Attachment I to JPN-93-028

PROPOSED TECHNICAL SPECIFICATION CHANGES
REVISION OF TABLE 4.7-2

JAMES A. FITZPATRICK NUCLEAR POWER PLANT
Docket No. 50-333
DPR-59

**SAFETY EVALUATION FOR
PROPOSED TECHNICAL SPECIFICATION CHANGES
REVISION OF TABLE 4.7-2 (JPTS-89-038 AND JPTS-92-009)**

FIGURE 1

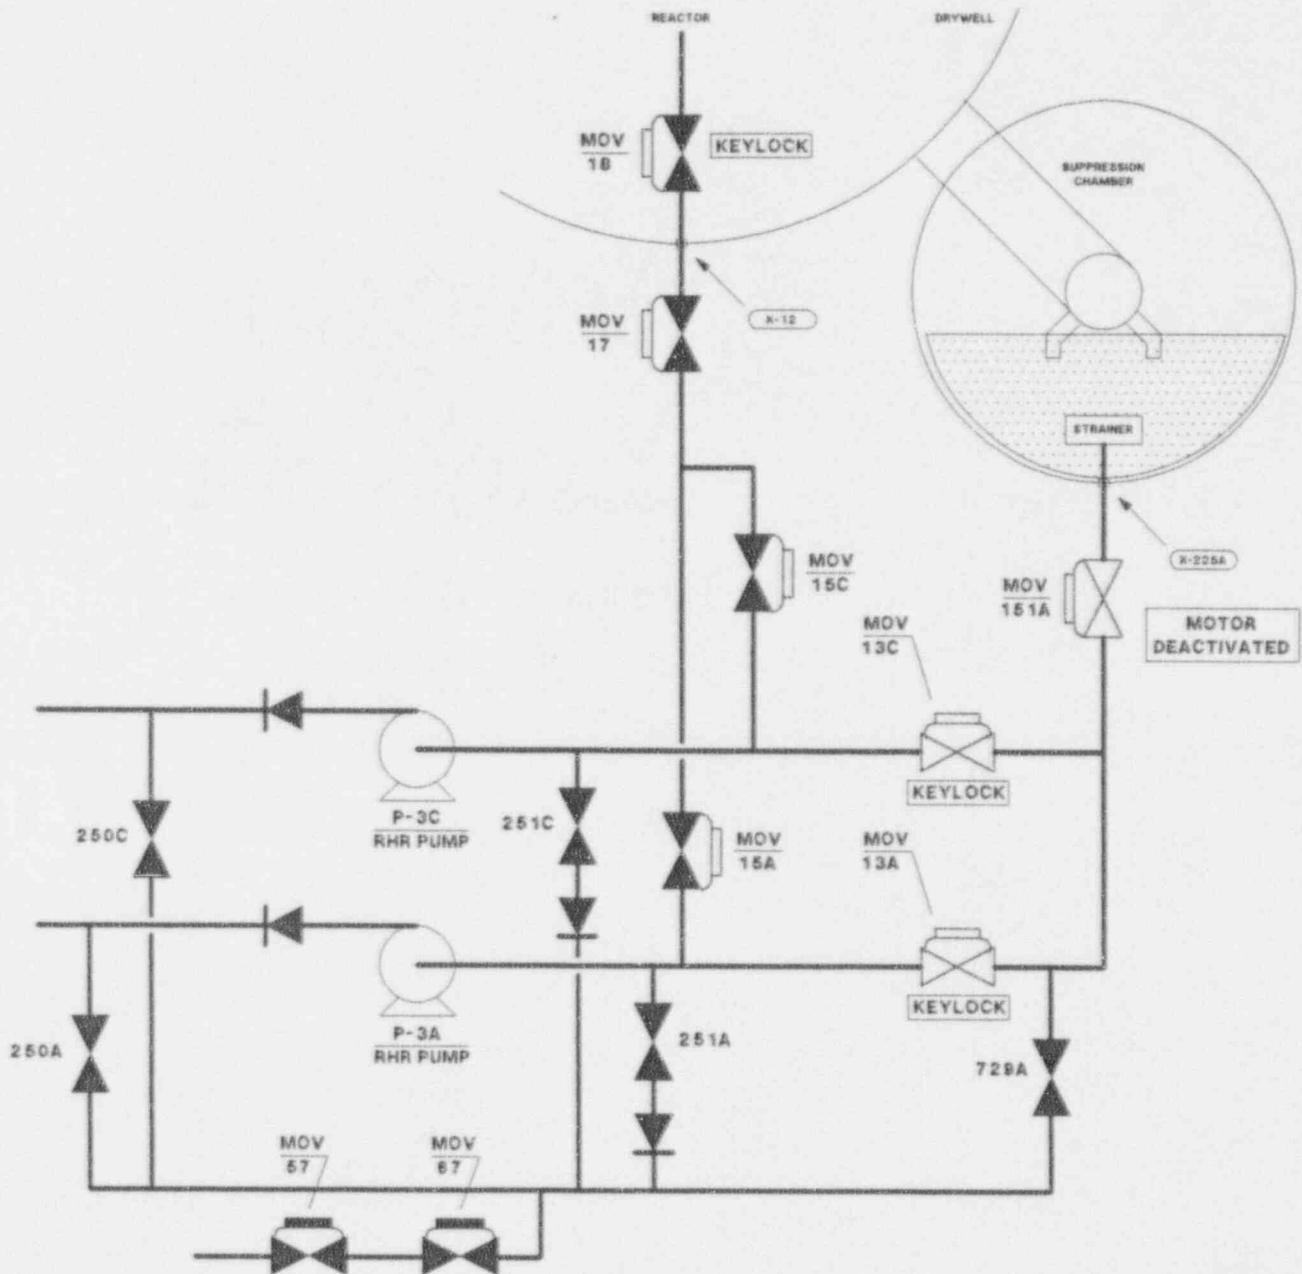
10MOV-57 and 10MOV-67 receive the same Primary Containment Isolation Signals (PCIS) as shutdown cooling suction containment isolation valves (CIV) 10MOV-17 and 10MOV-18. These valves are on a line (Figure 1) that connects the Residual Heat Removal (RHR) system to the radwaste system to provide drain down capability and are normally closed. Additional isolation is provided by closed manual isolation valves, i.e., 10RHR-250A&C, 10RHR-251A&C, and 10RHR-729A, located upstream of 10MOV-57 and 10MOV-67. The presence of PCIS signals implied that valves 10MOV-57 and 10MOV-67 performed a safety related purpose.

A safety evaluation (Reference 2) was performed to determine if these valves were CIVs as defined by the FitzPatrick licensing basis. The safety evaluation concluded that 10MOV-57 and 10MOV-67 were incorrectly classified as CIVs. PCIS signals activate 10MOV-57 and 10MOV-67 to automatically isolate this line to prevent a loss of water from the lines between the RHR pumps and 10MOV-17 after 10MOV-17 has been closed and to prevent flow diversion on Emergency Core Cooling System (ECCS) actuation.

During the evaluation process of determining if 10MOV-57 and 10MOV-67 were CIVs, it was noted that the drain down lines for both the "A" and "B" sides each included a manual isolation valve, i.e., 10RHR-729A upstream of 10MOV-67 on the "A" side and 10RHR-729B upstream of 10RHR-253 on the "B" side. The safety evaluation (Reference 2) which determined that 10MOV-57 and 10MOV-67 are not CIVs also concluded that isolation of the "A" side RHR drain down line branching out of penetration X-225A leading to the radwaste system is performed by 10RHR-729A (see Figure 1). Isolation of the RHR to radwaste system "B" side drain down line is similarly handled by 10RHR-729B for penetration X-225B.

Delete valves "10MOV-57" and "10MOV-67" for containment penetration X-225A.

Add valve "10RHR-729A" for containment penetration X-225A.

Add valve "10RHR-729B" for containment penetration X-225B.

FIGURE 2

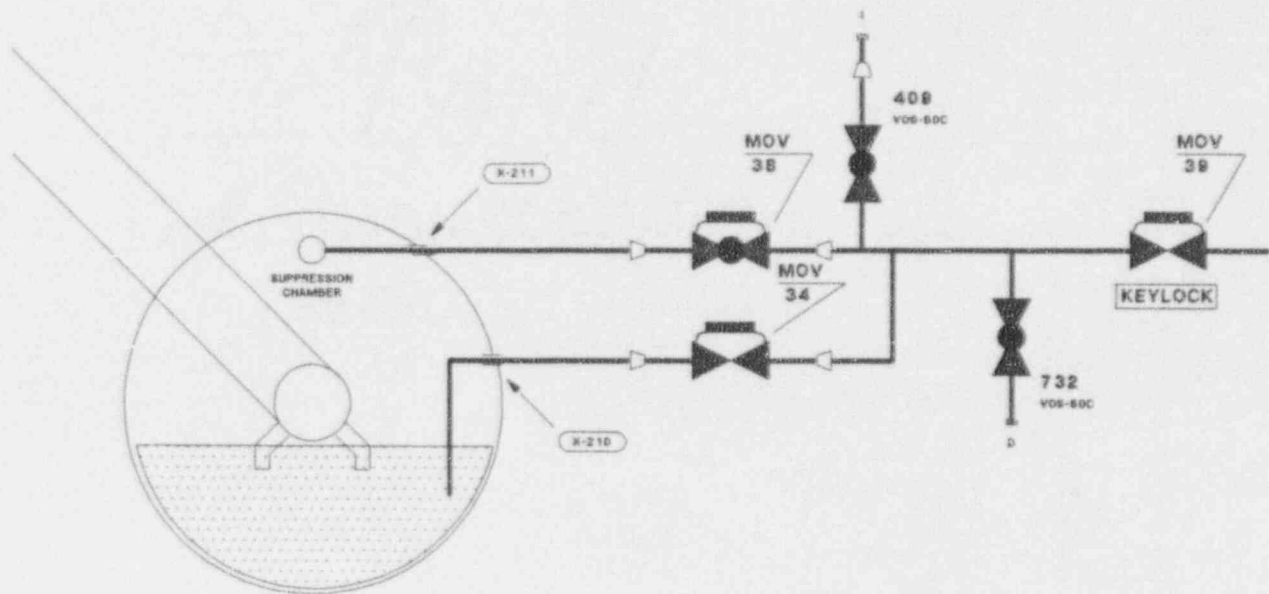
The changes to page 213 clarifies that CIVs 10MOV-34A and 10MOV-34B are exempt from Type C (local leak rate) testing by deleting the references to their inclusion in the testing of penetrations X-211A&B, respectively. These valves are on lines which terminate inside the torus below the low torus water level (see Figure 2). Technical Specification 4.7.A.2.c.(3.) specifically exempts "Valves, which are sealed with fluid from a seal system, such as the liquid in the suppression chamber ..." from Type C testing.

Because of the configuration of penetrations X-210 and X-211, valve 10MOV-34 must be closed to test valves 10MOV-38 and 10MOV-39. In the test configuration, all three valves are closed to create a test volume. During the test, this volume is pressurized and the total leakage from the volume is measured as a function of time. Because 10MOV-34 is exempt from a Type C Test, the leakage from the test volume is attributed to valves 10MOV-38 and 10MOV-39. This is conservative because it over estimates the leakage through these two valves.

For containment penetration X-210A, page 213, in the "Local Leak Rate Test Performed" column, delete the phrase:

"Valve 10MOV-34A is tested during the Type C test of Penetration X-211A."

For containment penetration X-210B, page 213, in the "Local Leak Rate Test Performed" column, delete the phrase:

"Valve 10MOV-34B is tested during the Type C test of Penetration X-211B."
